The DZ Company, LLC
4321 W. Eisenhower Blvd.
Loveland, CO 80537
970-667-2254

Sienna Construction Note

10/25/09

Cable issues

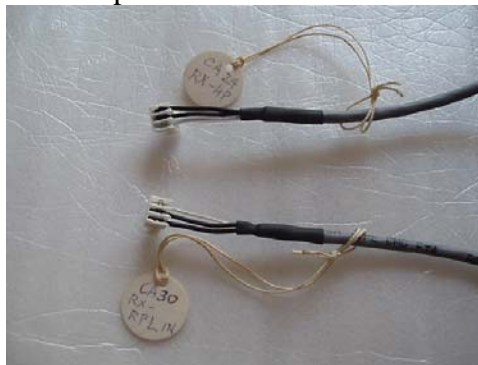
1. CA14 (CONT-RXVOXST), the cable that goes from the controller to the receiver board, carries the VOX, AntiVOX and CW Sidetone signals. It should be a 4-pin cable, but was manufactured as a 3-pin cable. A new one is being prepared and will be shipped as soon as possible. You can turn on the receiver section without this cable. If you want to verify the Sidetone functionality, use CA18 (CONT-TXVM) temporarily.
2. CA24 (RX-HP), CA30 (RX-RPLINEIN) and CA31 (RX-RPLINEOUT) look almost identical. CA31 is much longer than the other two (approx. 15"). CA24 is one inch longer than CA30 and has an opposite pin assignment. You can identify CA24 and CA30 from this picture:
